# UNITED STATES PATENT AND TRADEMARK OFFICE

APPLICATION NO.	FILING DATE	FIRST NAMED INVENTOR	ATTORNEY DOCKET NO.	CONFIRMATION NO.
09/784,093	02/16/2001	In-Duk Song	8733.398.00	3221

<b>Office Action Summary</b>	<b>Application No.</b>	<b>Applicant(s)</b>	
	09/784,093	SONG ET AL.	
	<b>Examiner</b>	<b>Art Unit</b>	
	Tarifur R Chowdhury	2871

## DETAILED ACTION

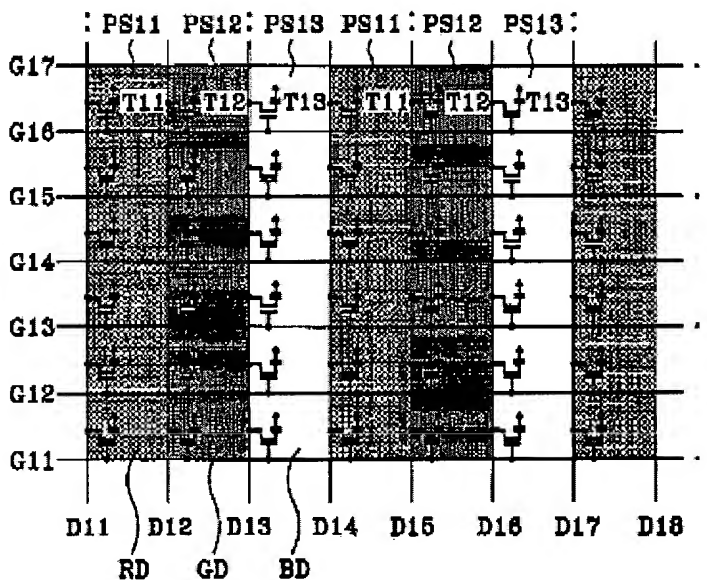
5. The AAPA described in the present application discloses in pages 1-6 and shown in Figs. 3 and 4, discloses, a liquid crystal display device comprising:

- a liquid crystal panel (111) having a plurality of gate lines (117) and data lines (119) and a plurality of sub-pixels, wherein the gate lines (117) are arranged in a transverse direction and the data lines (119) are arranged in a longitudinal direction,

wherein each sub-pixel is defined by the gate and data lines and corresponds to a color filter that has one of red, green, blue and white colors;

- a gate driver integrated circuit ( 113b) connected to the plural gate lines (117) for driving the gate lines, the gate driver IC arranged on a first side portion of the liquid crystal panel (111); and

- a data driver integrated circuit (115a) connected to the plural data lines (119) for driving the data lines, the data driver IC arranged on a second side of the liquid crystal panel (111).

As to claim 30, the AAPA described in the present application shows in Fig. 3 that only one sub-pixel corresponding to a color filter that has red, green, blue and white

colors and each data line is connected to a sub-pixel corresponding to one of the color filters. Further, it is known that a single liquid crystal display panel comprises a plurality of sub-pixels. Therefore, it would have been obvious to one of ordinary skill in the art that each data line is connected to a plurality of sub-pixels each corresponding to one of the color filters having a same color.
